ADDENDUM NO. 1

PROJECT: Benton County Sanitary Landfill
Leachate Storage Lagoon

PROJECT NO.: 6043-23B.440

DATE: March 11, 2025

FIGURE: 18 AD-1

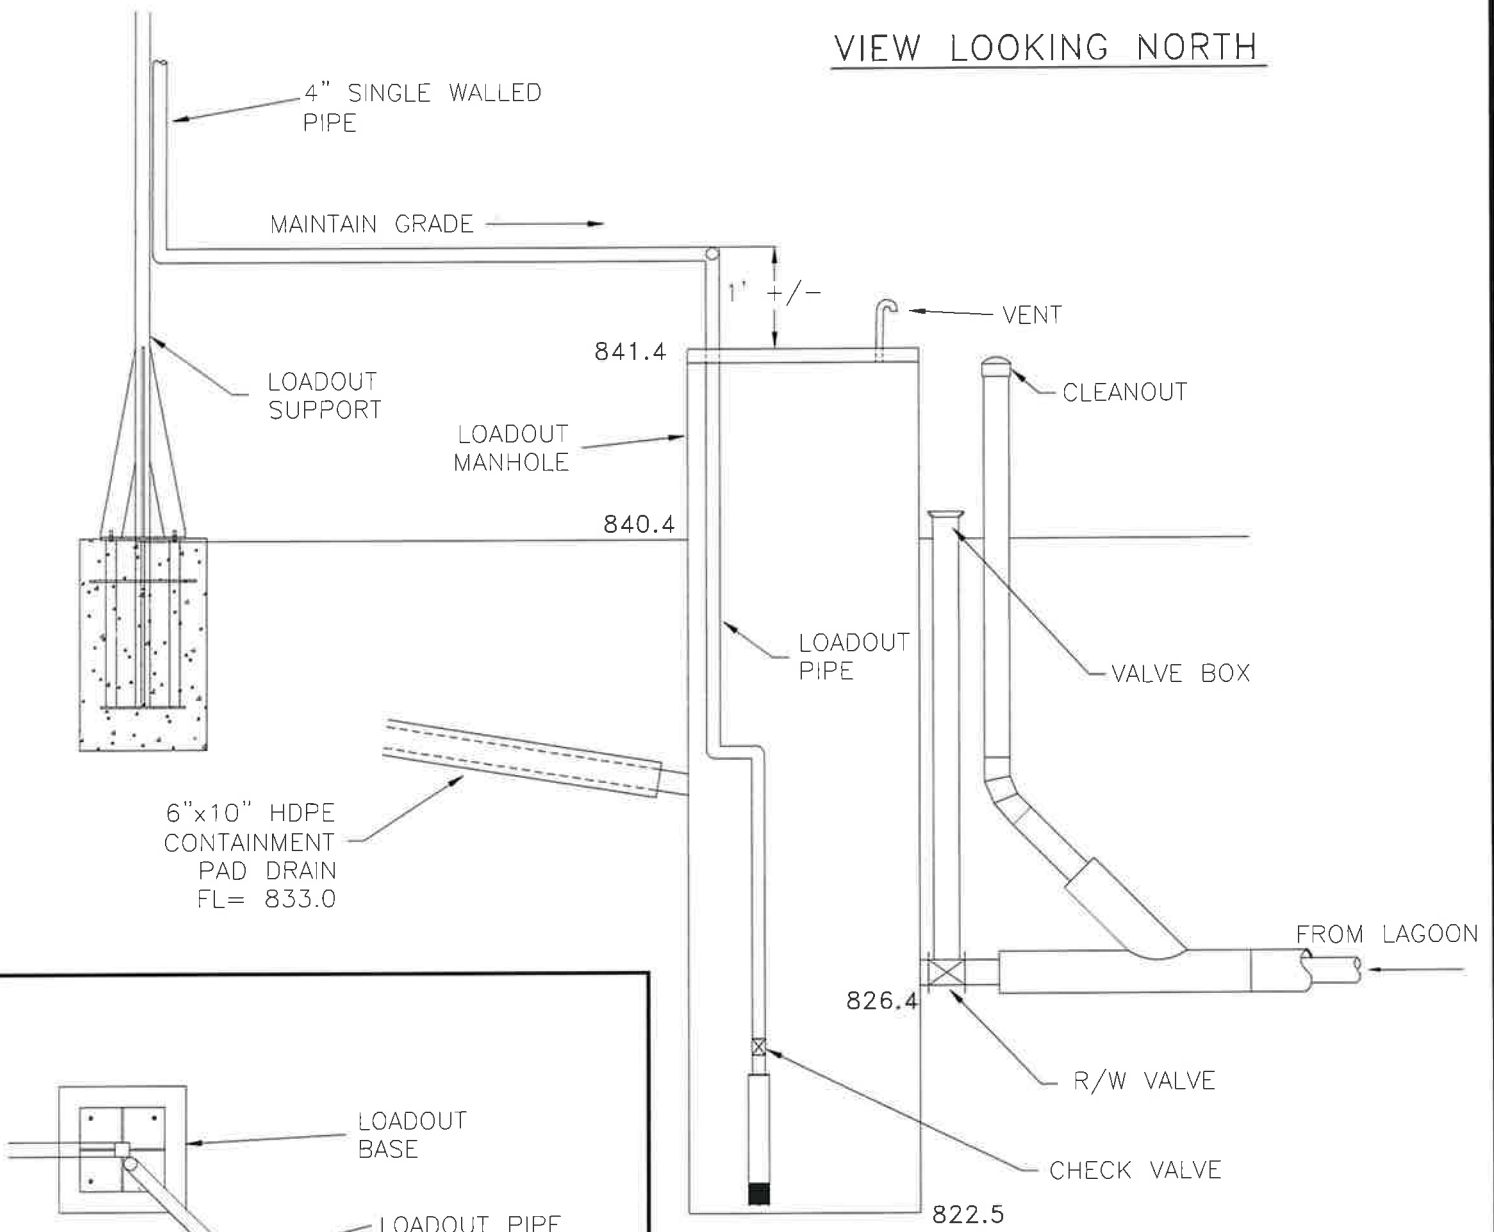
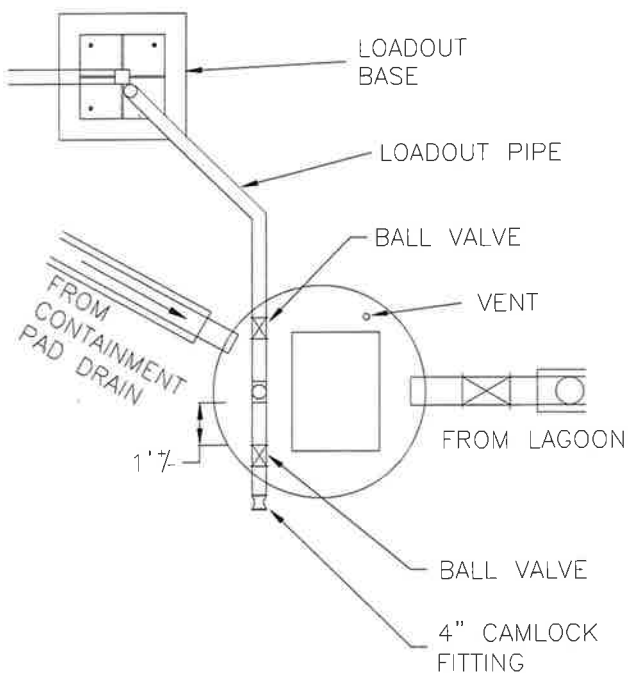
Two ball valves shall be installed in the loadout pipe at the approximate locations shown on Figure 18 AD-1. The ball valves shall be Type-21/21A as manufactured by Ashai/America or preapproved equal. One of the ball valves shall be connected to a 4" stainless steel female camlock connection as shown on Figure 18 AD-1. Connections to the valves and the camlock shall be as per manufacturers recommendations. The Contractor shall be responsible to confirm compatibility with landfill equipment prior to ordering the camlock. Valves and camlock are incidental to this item.

The horizontal portion of the loadout pipe shall be supported with an adjustable pipe support and clamp in two locations, at the elbow location shown on Figure 18

AD-1 and at the loadout (to replace the welded pipe support bracket). Cost of supports/clamps is incidental to this item.

A revised Figure 18 is included changing the rim elevation of the loadout manhole and revising the notes to replace the welded pipe support bracket with adjustable supports/clamps.
